30-039-23402 CANYON LARGO UNIT #340
HILCORP ENERGY COMPANY

HILCORP ENERGY COMPANY
CANYON LARGO UNIT 340
TA or P&A NOI

Re: Permanent Abandonment
Well: Canyon Largo Unit 340

CONDITIONS OF APPROVAL

CANYON LARGO UNIT 340 - PROPOSED P&A WELLBORE SCHEMATIC

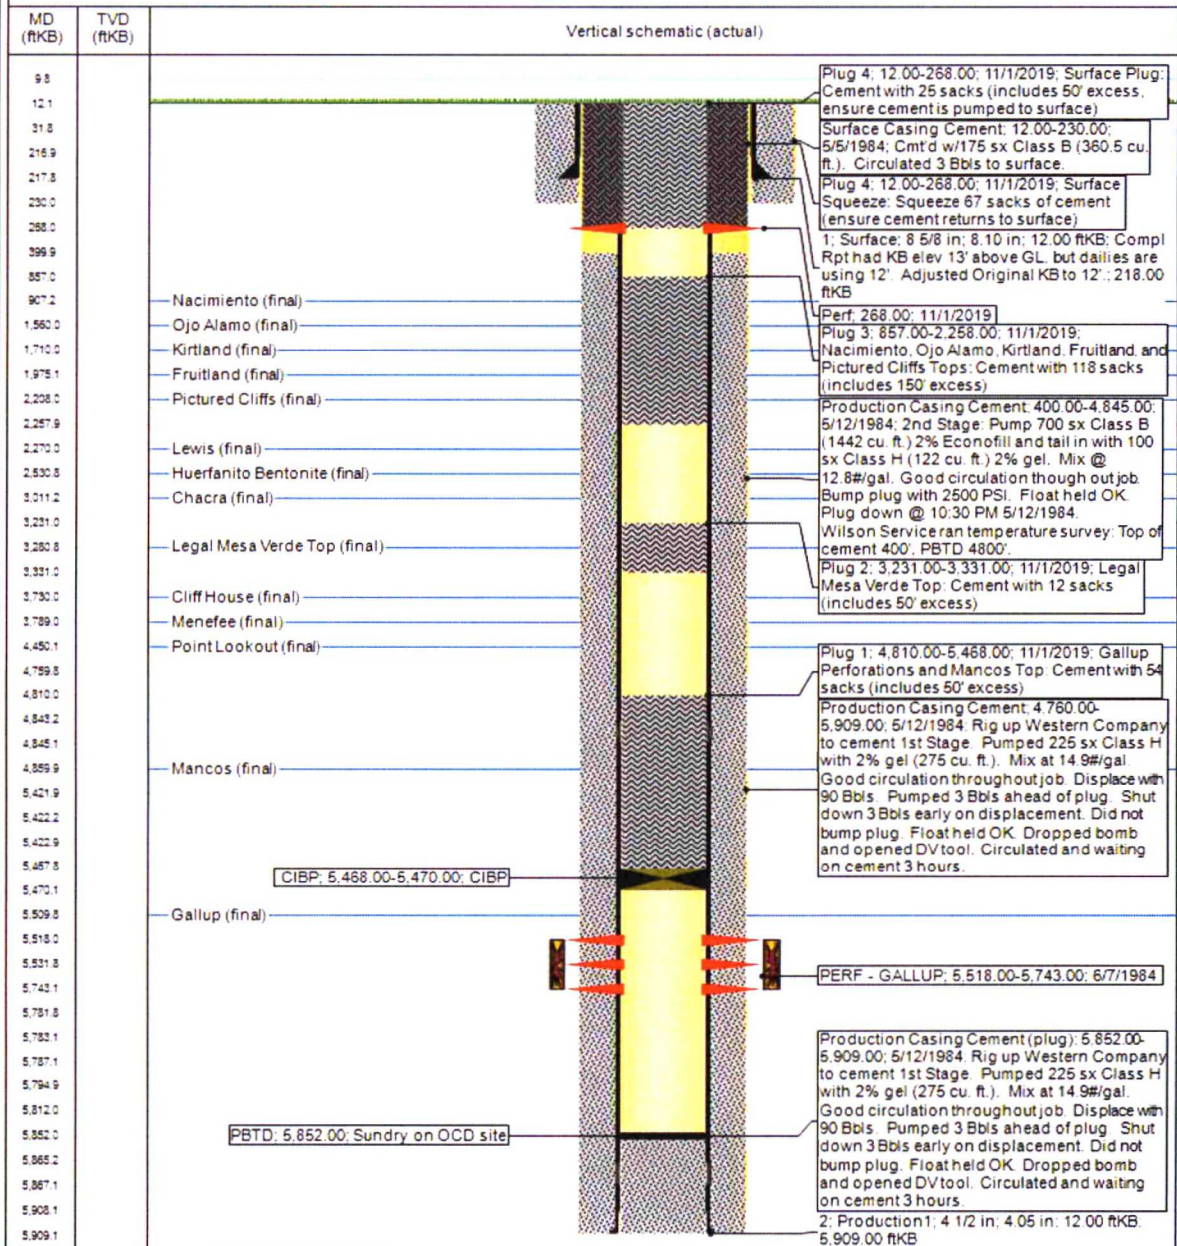
- Notify NMOCD 24hrs prior to beginning operations.
- Extend the Mancos/Gallup Plug 5468'-4561'. OCD Mancos top:4611'
- Add a Chacra Plug 3061'-2961'. OCD top: 3011'

1. Plugging operations authorized are subject to the attached "General Requirements for Permanent Abandonment of Wells on Federal and Indian Lease."
2. Farmington Office is to be notified at least 24 hours before the plugging operations commence (505) 564-7750.
3. Submit electronic copy of the CBL for verification to the following addresses: jkillins@blm.gov and Brandon.Powell@state.nm.us . Based on CBL results inside/outside plugs and volumes will be adjusted accordingly. Please review the General Requirements document to ensure volumes meet required excess inside and outside casing.
4. Add an additional plug (3,680'-3,780') to cover Cliffhouse top at 3,730'.
